# Legalelectric, Inc.

April 19, 2023

RE: Initial Comments on Lava Ridge Wind Project DEIS

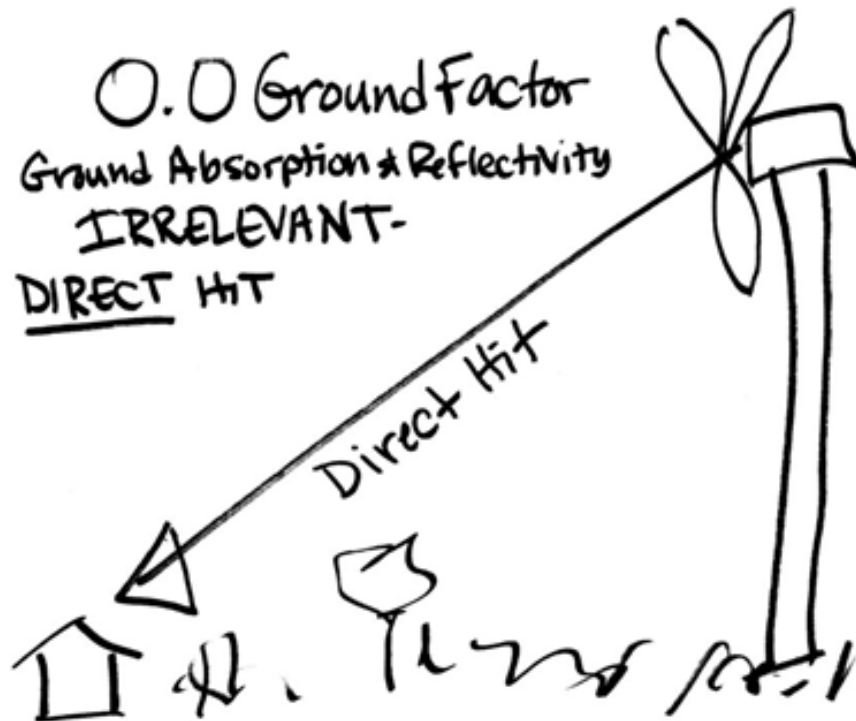
Attached as Exhibit D please find a Comment I filed in a Minnesota Power Plant Siting Act hearing docket, raising the issue of misuse of ground factor. Misuse in modeling is use of a ground factor of other than 0.0 for an elevated source. The use of a 0.0 ground factor in modeling an elevated noise source has been addressed in testimony in Wisconsin dockets by two noise experts, that 0.0 is the ground factor to be used.

The 0.0 ground factor for elevated sources is necessary because for an elevated noise source, the path to "receptors" is uninterrupted, it's a direct line, there is no ground absorption:

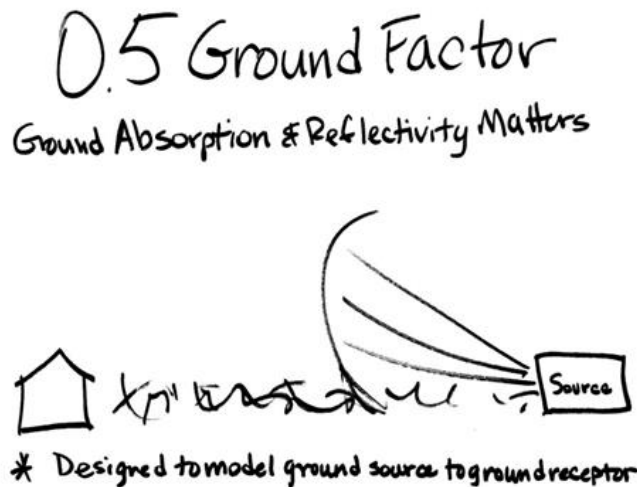
The use of a 0.5 ground factor is only appropriate for modeling predicted noise impacts for a ground source to a receptor on the ground to address muffling interference in between:
